Meeting Date: Tuesday 18 June 2013
Location: Committee Room 2, Level 5, Civic Centre, 1 Devlin Street, Ryde
Time: 5.00pm

NOTICE OF BUSINESS

Item		Page
1	CONFIRMATION OF MINUTES - Meeting held on 4 June 2013	4
2	29 SHEPHERD STREET, RYDE. LOT C DP 327043. Local Development Application for new two storey attached dual occupancy and inground swimming pools. LDA2013/0001.	11
3	18 SHEPHERD STREET, RYDE. LOT 70 DP 5887. Local Development Application for new two storey attached dual occupancy. LDA2012/144.	51
4	68 CHAMPION ROAD, TENNYSON POINT - LOT 21 DP 233234. Local Development Application for extension of boundary fencing within foreshore building line. LDA2013/0080.	92

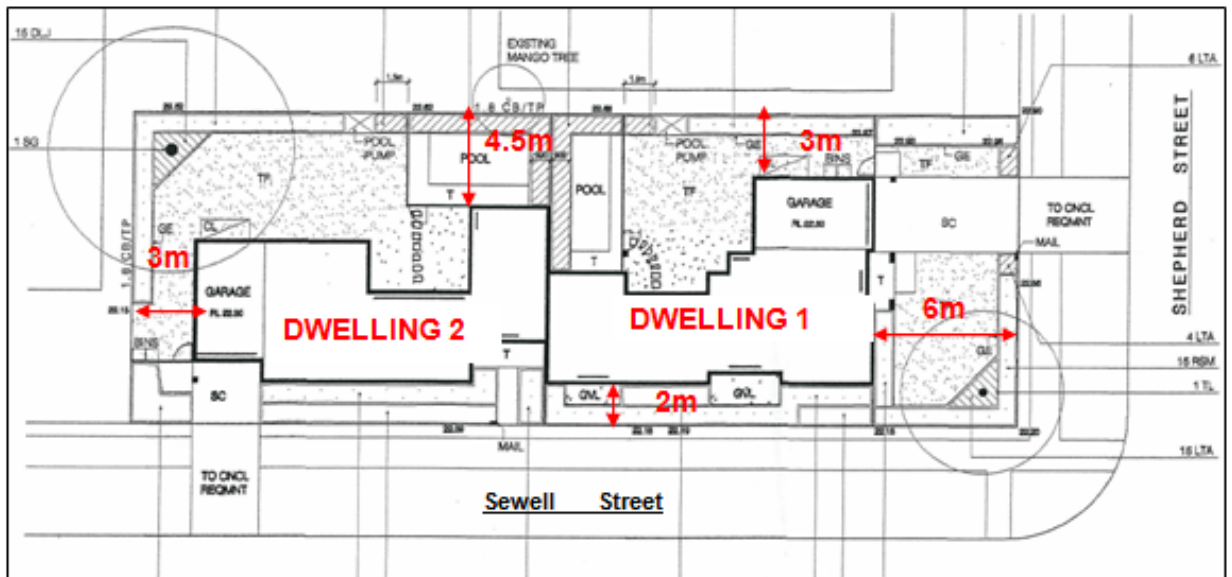
A. Built Form (Setbacks). *“The design is problematic in that it adopts a long thin building footprint that extends along the Sewell St frontage with a minimal building line of only 2.0m and a rear setback of only 3.0m. The building presents with a visually jarring elevation and a confused and disjointed roofline. The building is 34m in length on a 2.0m building line with minimal articulation and thus dominates the Sewell St streetscape.*

This is not the built form envisaged by the Development Control Plan 2010 (DCP) at page 11 where corner blocks are addressed and the larger setback is provided to the longer frontage street that is Sewell Street. The primary frontage in this case appears to be Shepherd St where 6.0m has been adopted. The DCP would also call for a 10.785m rear setback and due to the long skinny built form this is in no way complied with a setback of only 3.0m being achieved. The built form is very different to adjacent residential homes and as such will be out of place in its environment.”

Comment: Council’s DCP 2010 prescribes a 6m front setback, and a 2m “secondary” setback for corner allotments. The subject site is located at the corner of Shepherd and Sewell Streets with its primary frontage facing Shepherd Street and its secondary frontage facing Sewell Street. The development proposes a primary front setback of 6m from Shepherd Street and a secondary setback of 2m from Sewell Street which complies with the above requirements. Council’s DCP does not contain any controls regarding the length of wall along a secondary setback (which appears to be the main issue of concern in the objection), however the development is designed to incorporate articulation and variation along the façade, which will ensure that its presentation to Sewell Street is acceptable.

The above diagram shows the proposed setbacks including, primary and secondary setbacks of the new attached dual occupancy

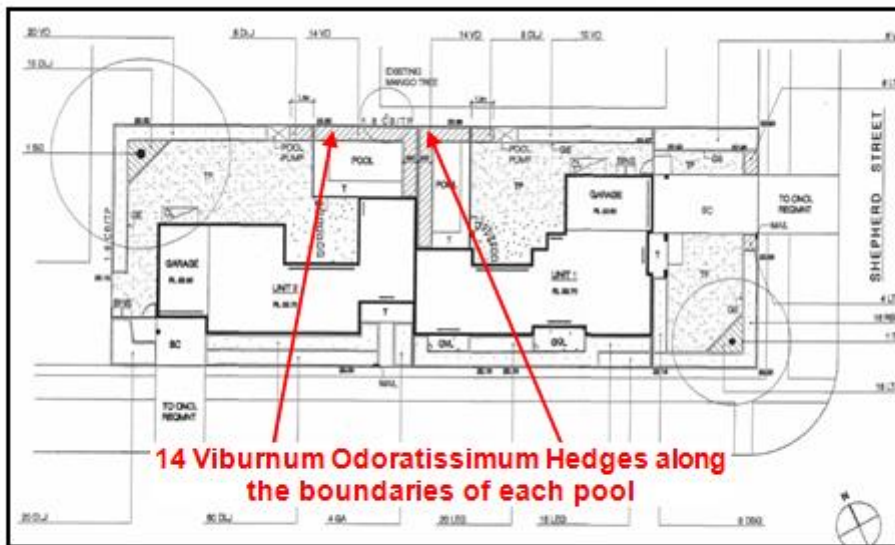
B. Deep soil areas and location of pools. “Additionally, in adopting the proposed footprint the private open space for both houses is located along the common boundary with No.27 Shepherd St including two swimming pools immediately adjacent to each other with no landscape setback to the boundary. The long skinny footprint again prevents achievement of the 8.0m X 8.0m area of deep soil planting.”

Comment: Ryde DCP 2010 requires a deep soil area measuring 8m x 8m in the rear yard, and only one such area is required for dual occupancy developments. The development provides an area measuring 6.24m x 11.6m (ie 72.38m²) within the courtyard of dwelling 2. Whilst this does not strictly comply with the 8m x 8m requirement, the area provided will enable space for tree growth, as well as outdoor recreation space for the occupants.

The above diagram shows the inclusion of screen planning along the boundaries of the site.

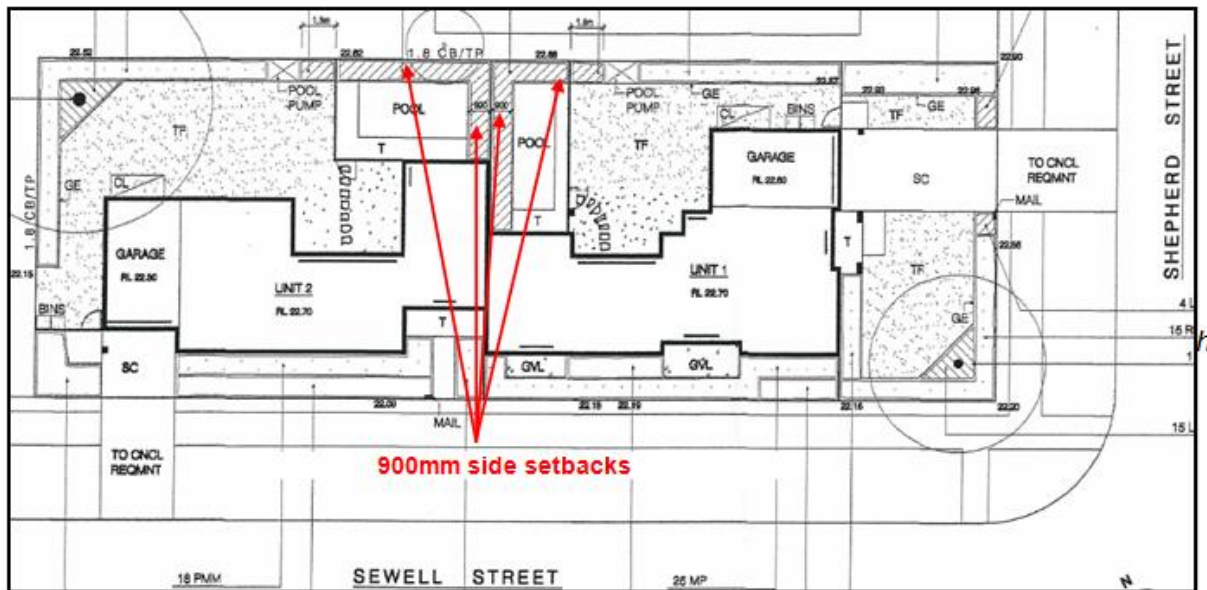
In relation to concerns about landscaping adjacent to boundaries, each swimming pool proposes a 900mm setback from the northern boundary of the site as well as the common boundary of the two units which meets Council’s DCP requirements. The development also includes screen planting along the boundaries of the pools in particular along the northern boundary of the site and as well as along the common boundary between the two pools. This landscaping is shown in the following drawings.

The shadow diagrams for the development are shown as follows:

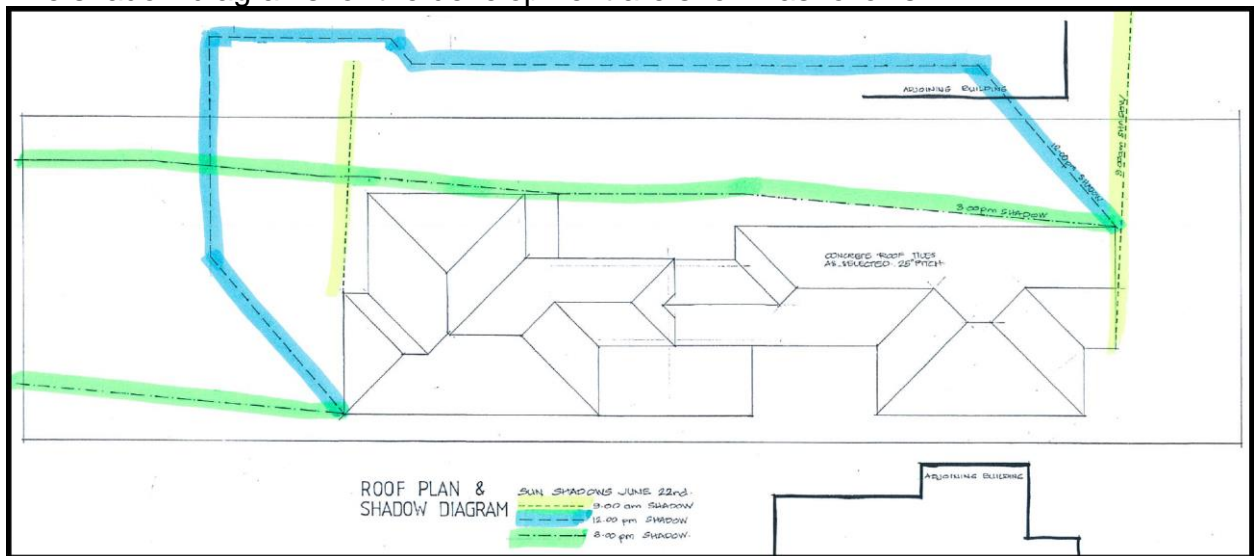
Comment: The concerns regarding overshadowing of No 20 Shepherd are also supported. Given the orientation of the land, No 20 (to the south) is likely to be affected by any 2-storey development on this site. However the style of the development proposed (with a longer than usual 2-storey building) will increase the overshadowing impact to this neighbour compared to a more typical 2-storey development.

Although the development would cause substantial overshadowing of the private open space of the rear yard of No 20, it would comply with the above requirement of DCP 2010 because it still would allow sunlight to more than 50% of the private open space (and for more than 2 hours). In terms of impacts on north-facing living rooms, the shadow diagrams show that the living area windows of No 20 would not receive the required 3 hours of sunlight.

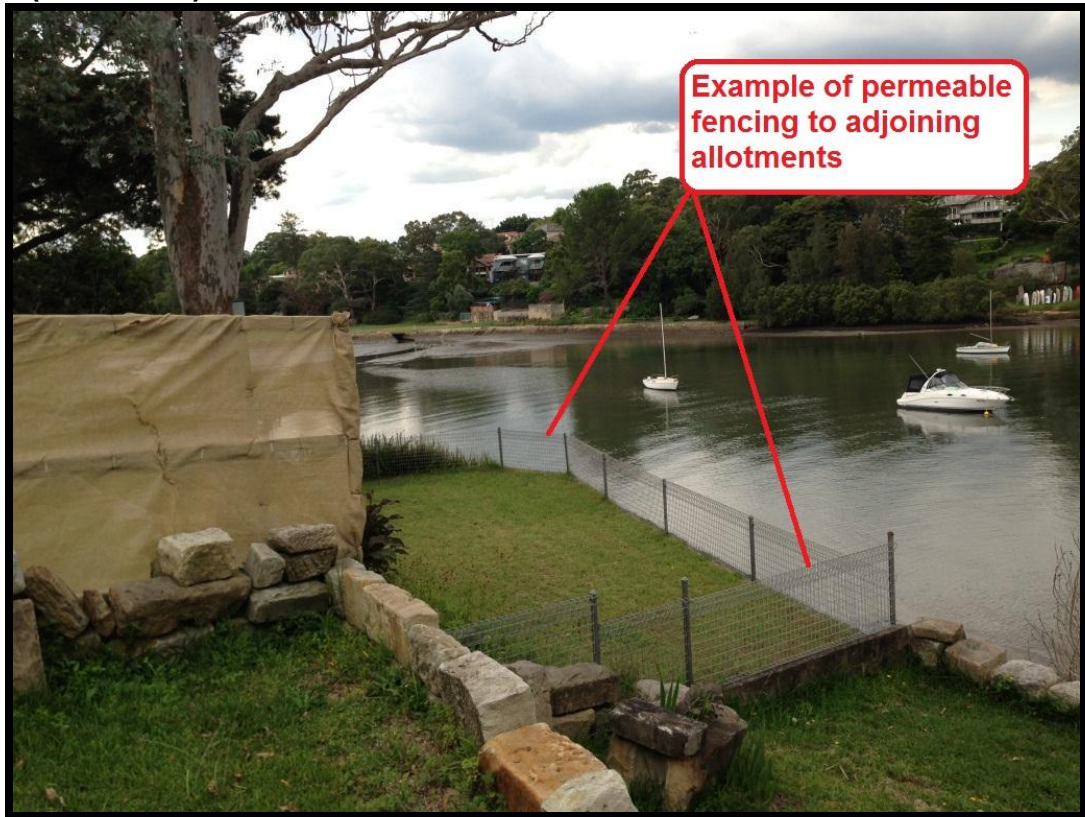
In response, one (1) submission was received from the owner of the neighbouring property as shown on the air photograph earlier in this report. The key issues raised in the submission are summarised and discussed as follows.

A. Permeability of the Fence – concerns are raised over the solid style of fencing that is proposed which does not comply with Council's DCP in regards to fencing forward of the Foreshore Building Line.

Comment: As identified in Council's preliminary assessment of the development application, the proposed fencing does not comply with Section 2.15 of Part 3.3 of the Ryde Development Control Plan 2010.

Photo showing location of existing and proposed fence

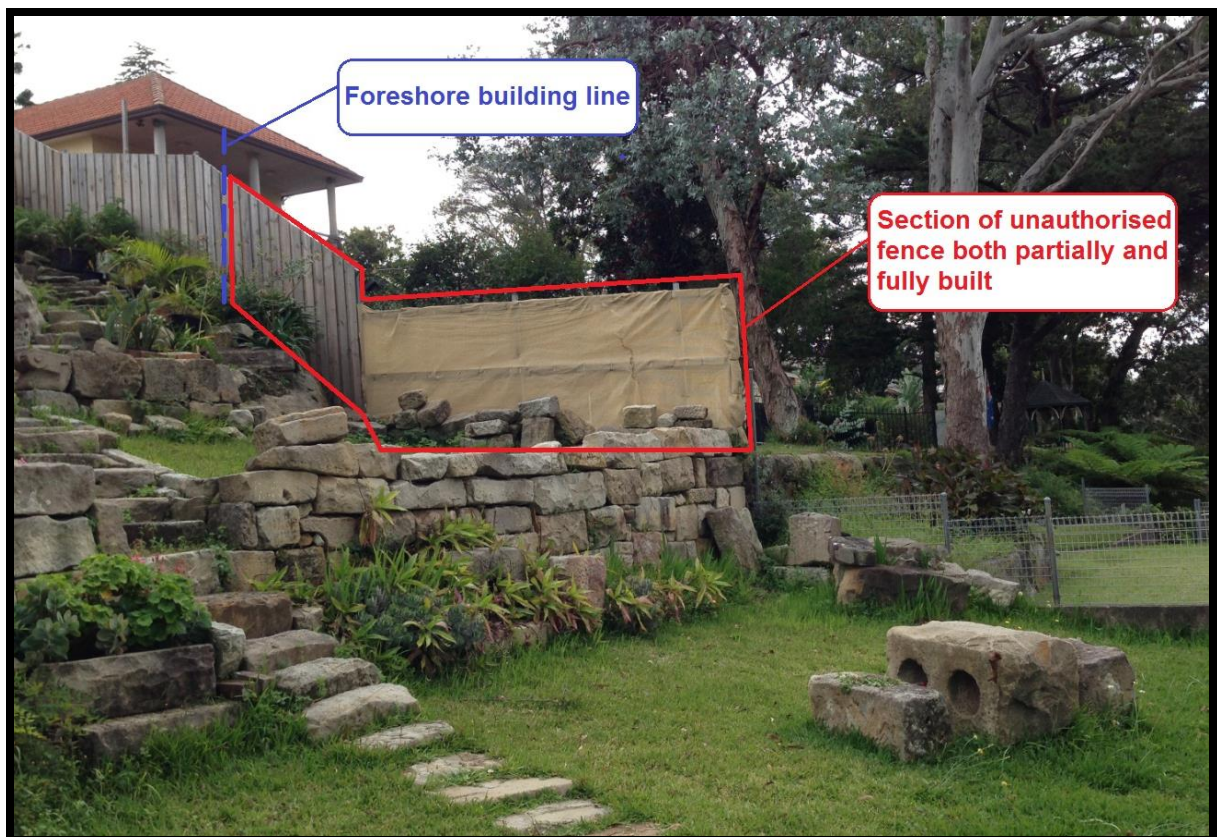
C. Unauthorised Building Works – concerns are raised that the development application is for a section of fence that is already partially built and currently has a demolition order.

Comment: As identified in the preliminary assessment of the proposed development application, and is evident in the photo below, part of the proposed fence which extends forward of the foreshore building line has already been built without prior development consent.

An upper section of fence approximately 2m in length has also been fully constructed. It is noted that all fencing outlined in red in Figure 4 above is forward of the foreshore building line (dashed blue line).
